Access Compliance Report

Public Rights-of-Way

(Curb Ramps)

Intersection ID: 13859	Main Street: CLEVELAND_AV	Cross Street: RENSSELAER_AV	Location: W
ADA ID: 8E2E08CEA8DD	Ramp Type: PerpDiag	Initial Pass/Fail: Fail	Overall Compliance: No
Severity Score: 50			
Codes/Mitigation Info/Possible Solution		Field Measurements/Component Compliance

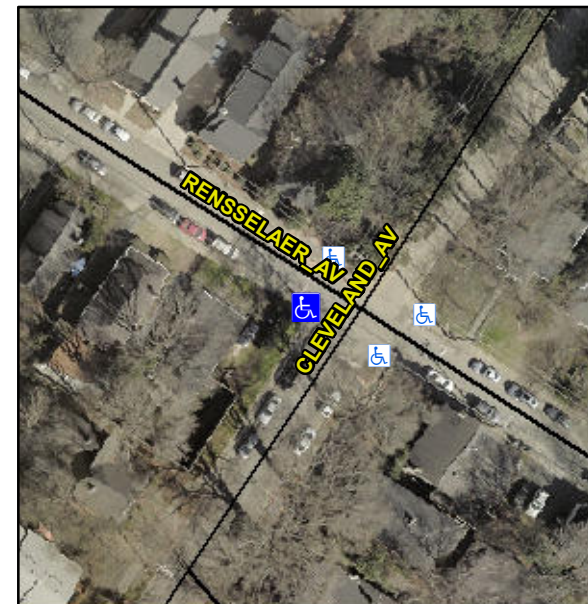
Not Found, R304.2.2, R304.5.3

Compliance	Description	Data	Compliance	Description	Data
N/A	Ramp Length (in)	60.0	No	Ramp Slope (%)	14.1
Yes	Ramp Width (in)	48.0	No	Ramp XSlope (%)	9.5
N/A	Flare Type LT	N/A	N/A	Flare Type RT	N/A
N/A	Flare Slope LT (%)	N/A	N/A	Flare Slope RT (%)	N/A
N/A	Flare Traversable LT?	N/A	N/A	Flare Traversable RT?	N/A
N/A	Landing Length (in)	N/A	N/A	DWS Provided?	N/A
N/A	Landing Width (in)	N/A	N/A	DWS Contrast?	N/A
N/A	Landing Slope (%)	N/A	N/A	DWS Length (in)	N/A
N/A	Landing X Slope (%)	N/A	N/A	DWS Full Width?	N/A
N/A	Landing Curb? (Y/N)	N/A	N/A	DWS Offset (in)	N/A
N/A	Shared Landing?	N/A			
N/A	Gutter Ponding?	N/A	N/A	Gutter Slope (%)	N/A
N/A	Gutter Lip Ht (in)	N/A	N/A	Gutter X Slope (%)	N/A
N/A	Painted X Walk1?	No	N/A	Painted X Walk2?	No
	X Walk 1 Direction	To SE		X Walk 2 Direction	To NE
N/A	X Walk 1 Width (in)	N/A	N/A	X Walk 2 Width (in)	N/A
	X Walk 1 Slope (%)	1.7		X Walk 2 Slope (%)	1.2
	X Walk 1 X Slope (%)	7.1		X Walk 2 X Slope (%)	0.1

Remove & Replace Curb Ramp With Two New Directional Ramps or Equivalent.
